SAFETY RECALL CAMPAIGN

TITLE: Hood Latch Replacement - North America

RECALL REFERENCE 010

DOCUMENT NUMBER: 12 A 006

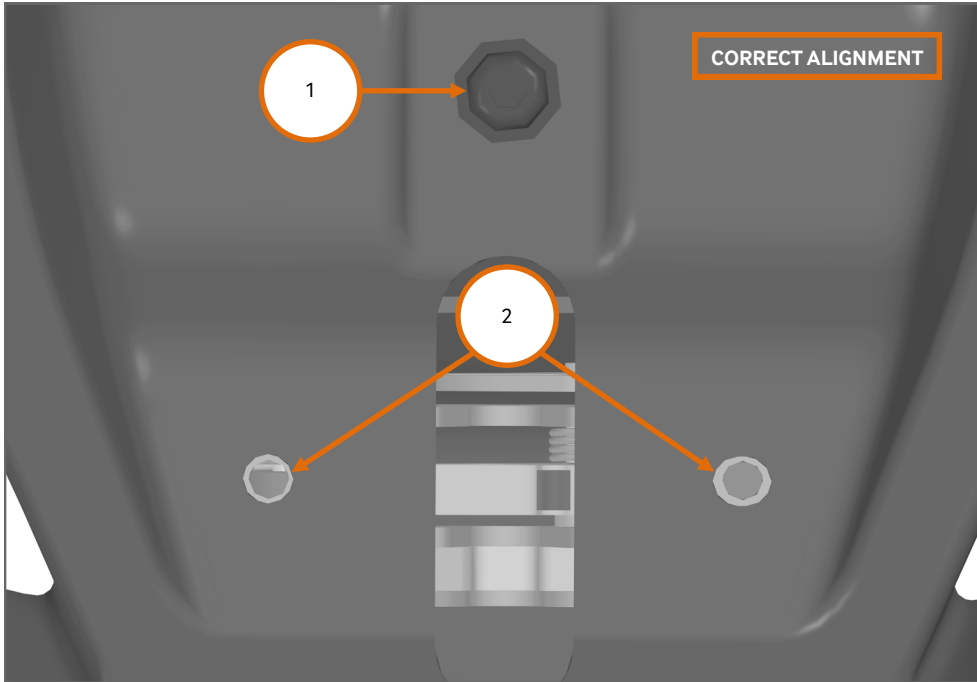
SITUATION: Due to a tolerance build-up of the internal components within the McLaren P1™ hood latch, there is a chance that when the secondary latch becomes disengaged (by pressing the button found in the hood) and is then re-engaged, the solenoid plunger in the secondary latch may miss the latch hole, causing the secondary latch to remain disengaged which would create a noncompliance with Federal Motor Vehicle Safety Standard No. 113.

If this occurs, the secondary latch will not function properly and may not retain the hood and the hood may open whilst the vehicle is moving, which could impair driver visibility and increase the risk of a vehicle crash.

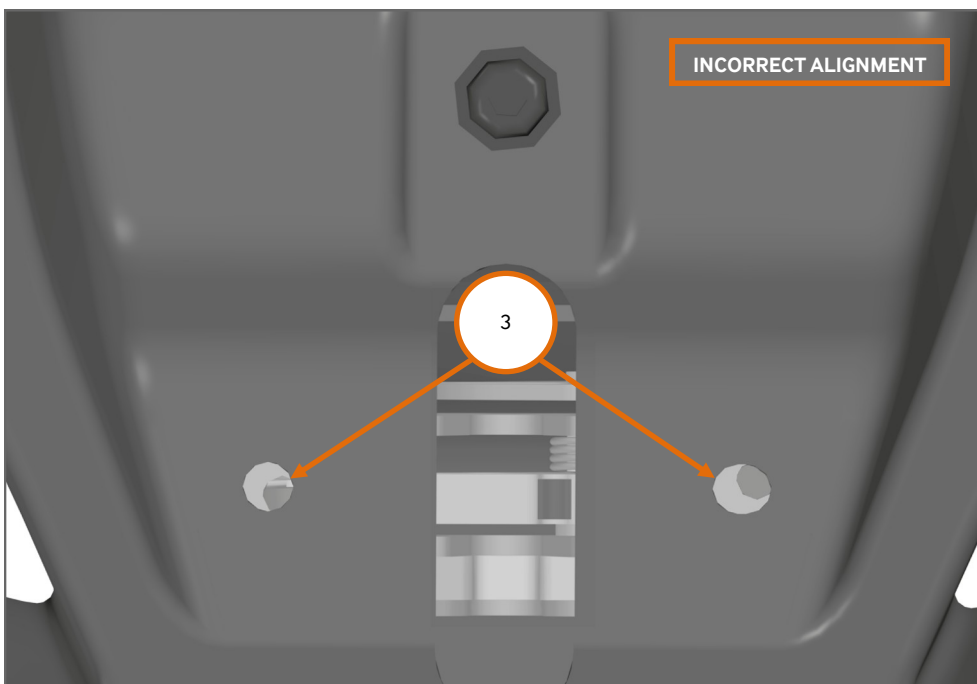
1. Please refer to BA-RM-02A052-03-001 Remove/install latch - Luggage compartment lid, to remove the hood latch.
2. Check for correct alignment of the new hood latch by fitting the top fixing bolt (1) and checking if the lower fixing points (2) of the latch are fully aligned with the holes in the front clam.
3. If the lower fixing holes (2) of the latch fully align with the clam fixing holes then proceed and install the new hood latch. Please refer to Step 8.

4. If the fixing holes of the latch are **not** fully aligned (3) with the clam fixing holes please refer to Step 5.

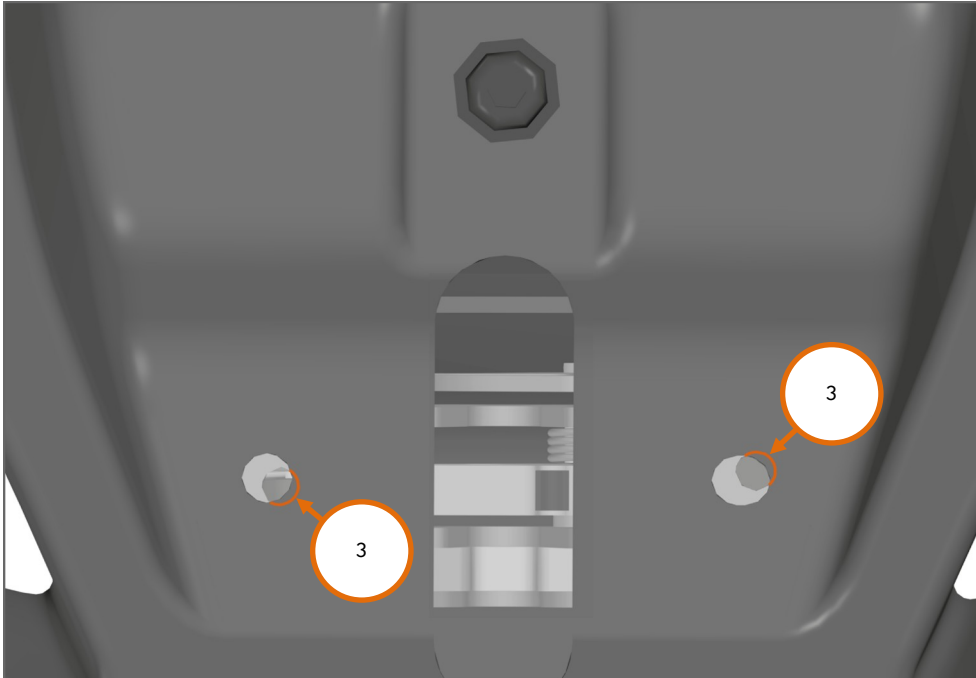
Care Point: Do not attempt to install the remaining two fixing bolts if the lower fixing holes are not aligned.

Care Point: Do not remove more than 3mm of material from any of the clam fixing holes.

Care Point: Remove an equal amount of material from each clam fixing hole in order to keep the latch centralised.

Care Point: Do not remove any material from the threaded latch fixing holes.

5. Mark up with a marker pen the area around the lower clam fixing holes where carbon material needs to be removed (3) to ensure that the fixing holes of the latch and the fixing holes of the clam are fully aligned.

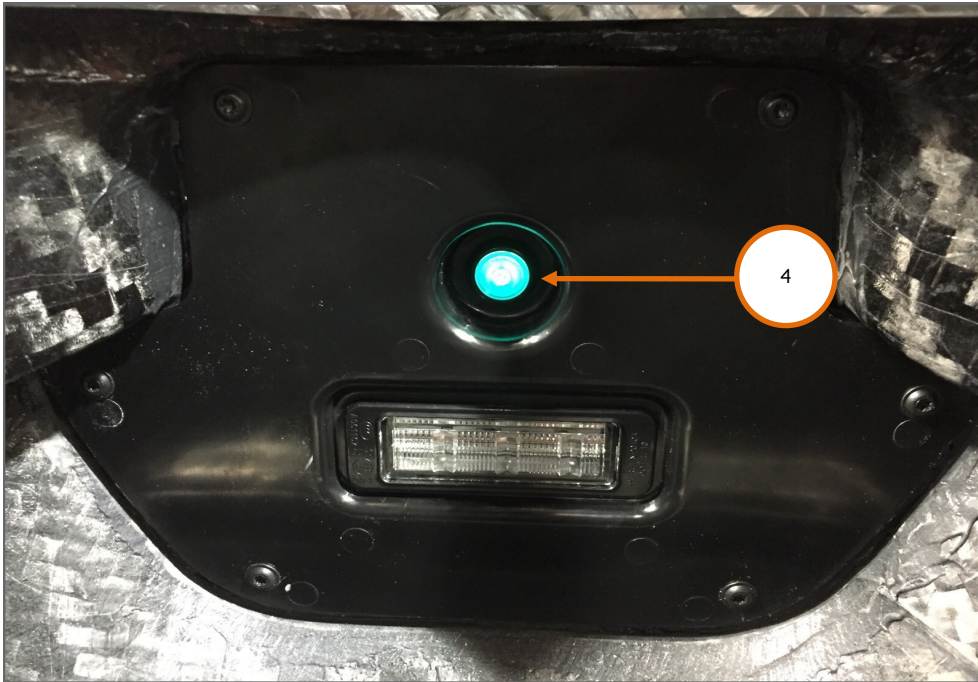
7. Using a needle file, remove material in the areas marked with paint at step 5.

10. Activate the hood latch using the emergency release button (Billy button) (4), located inside the luggage compartment.

Care Point: Do not operate the safety catch release button (5) located on the front of the vehicle.
